NUCLEAR POWER
SYSTEMS DIVISION
MFN 178-82

SUBJECT: IN THE MATTER OF 238 NUCLEAR ISLAND
GENERAL ELECTRIC STANDARD SAFETY ANALYSIS REPORT
(GESSAR II) DOCKET NO. STN 50-447

Attached please find draft responses to the Commission's October 5, 1982 request for additional information on Chapter 7 of GESSAR II. These responses reflect the NRC/GE information exchange meetings held in Bethesda October 14 & 15, 1982.

Figure 1

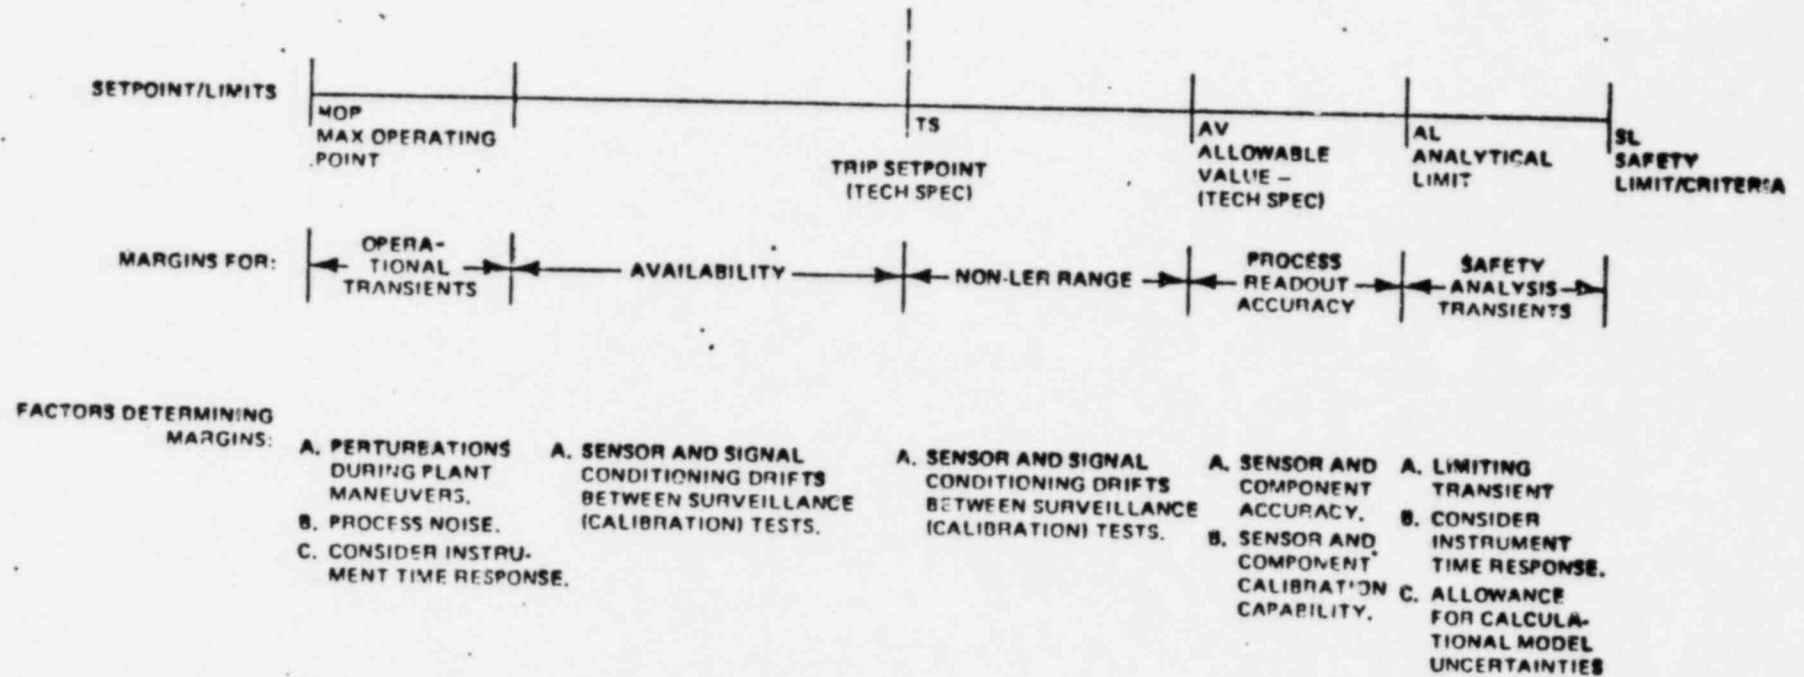
Provide a detailed discussion of your methodology to establish the trip setpoint and allowable value for each RPS and ESF channel, including the following additional information:

The method employed to establish adequate margins for instrument setpoint drift, inaccuracy and calibration uncertainty as discussed in NRC Regulatory Guide 1.105 is explained by reference to Figure 1. Because of the generic nature of this figure it is not drawn to any scale and is used solely to illustrate the qualitative relationships of the various margins. Starting with a Safety Limit as indicated at the extreme right hand of the figure, the first margin extends to the point marked Analytic Limit. This margin is there to account for uncertainties in the calculational model used but excludes allowances for instrumentation. Thus the calculational model can assume ideal or perfect instruments. The next margin is between the Analytical Limit and the Allowable Value of the parametric setpoint, and accounts for instrument errors and calibration capability for the specific instrumentation. The remaining margin which is of interest from a safety standpoint is that shown between the Allowable Value and the Instrument Setpoint. This margin is that which is deemed adequate to cover instrument drift which might occur during the established surveillance period. It follows that if during the surveillance period an instrument has drifted from its setpoint in a non-conservative direction but not beyond the allowable value, then the instrument performance is still within the requirements of the plant safety analysis. In this case, a Licensing Event Report (LER) would not be required.

For completeness Figure 1 shows further margin between the Instrument Setpoint and the Maximum (Licensed) Operating Point for the plant. During plant operation transient overshoots may occur for certain parameters and instrument "noise" may be present. The instrument setpoint may also drift in a conservative manner. There must be sufficient margin between the instrument setpoint and the maximum operating point to avoid spurious reactor scrams or unwarranted system initiations.

Not all parameters (functional units) have an associated analytical limit, and a Design Basis (DB) limit is indicated. In general, the analytic limit is employed in those cases where a functional unit setpoint is directly associated with an analyzed abnormal plant transient or accident as described in the FSAR, Section 15. Where a design basis limit is used it is not always possible to provide simple quantification of the limit, e.g., IRMs are only required to overlap in range with portions of the SRM and APRM ranges. A similar situation occurs with the main steam line radiation sensors which have a setpoint based essentially on previous operating experience.
